ADDENDUM NO. 1

Old Salem Infrastructure Improvements:
Section One – Streetlight, Tree and Sidewalk Improvements, Phase 1
Section Two – Stormwater Improvements
Section Three - Water and Sewer Improvements
FB No. 1858

September 26, 2017

ADDENDUM NO. 1 - FIGURE 2
OLD SALEM INC. PRIVATE BURIED ELECTRICAL SERVICE
 Old Salem Infrastructure Improvements
 City of Winston-Salem, NC
 FB#1858

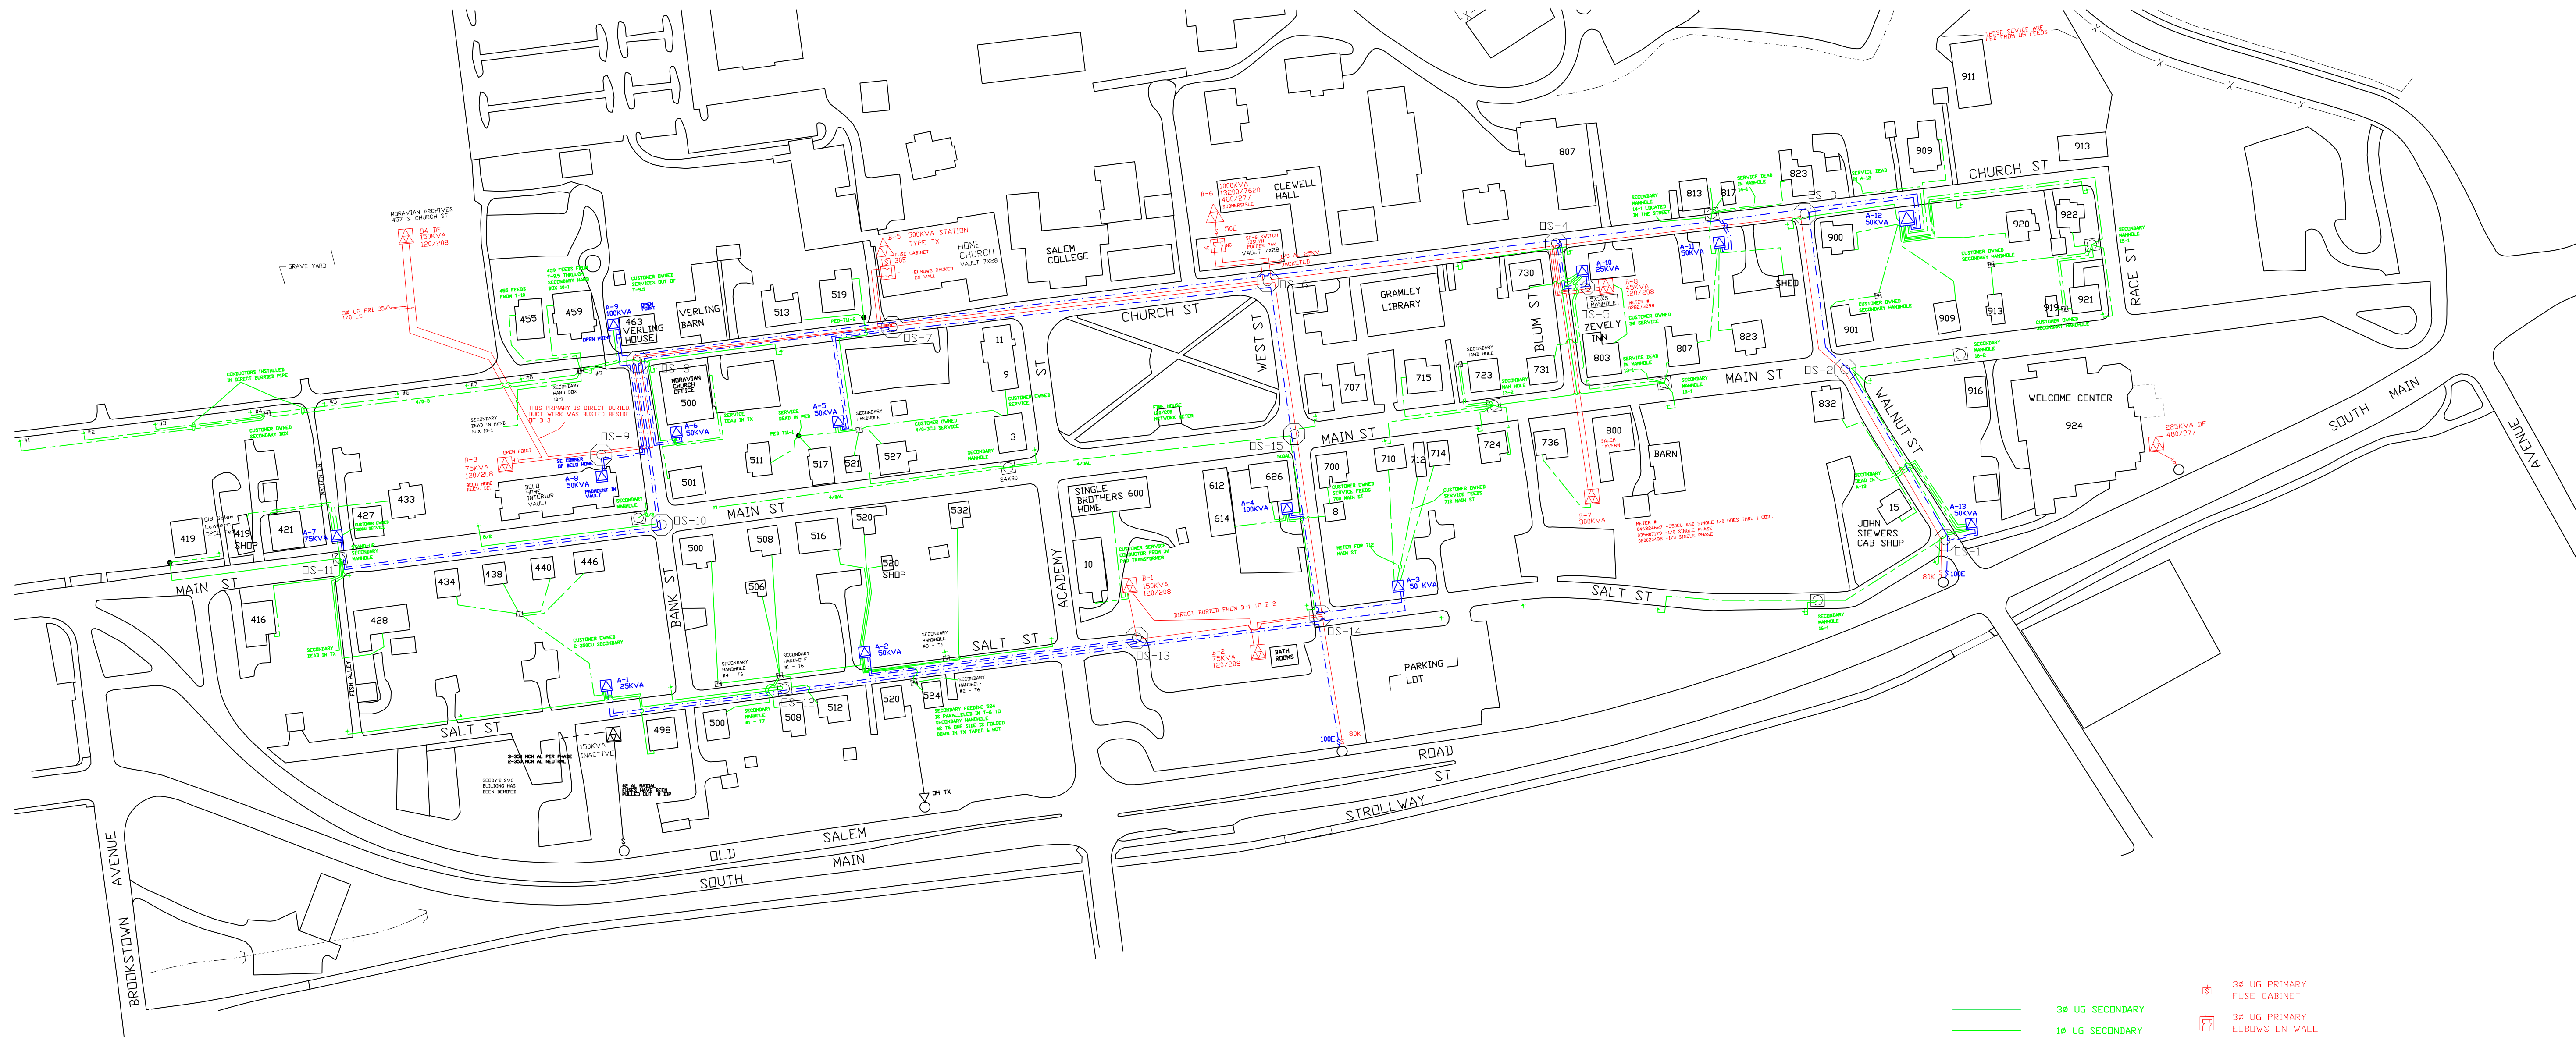
7. SHEET 3 OF 37 – Add “FIGURE 1” and “FIGURE 2” to this sheet as attached to this Addendum No. 1.
8. SHEET 19 OF 37 – Delete the words “3 INCH DIAMETER PIPE WRAPPED IN GEOTEXTILE TO NEAREST STORM DRAIN SYSTEM, TYP” and insert the words “3 INCH DIAMETER PIPE TO NEAREST STORM DRAIN SYSTEM, TYP”.
9. SHEET 32 OF 37 – At the intersection of WALNUT STREET and SALT STREET, for the Electrical Conduit from HANDHOLE 31 (HH31) to LP2, delete conduit from HH31 to LP2 and revise the conduit as shown on SHEET 35 of 37 Detail 2/E-6.
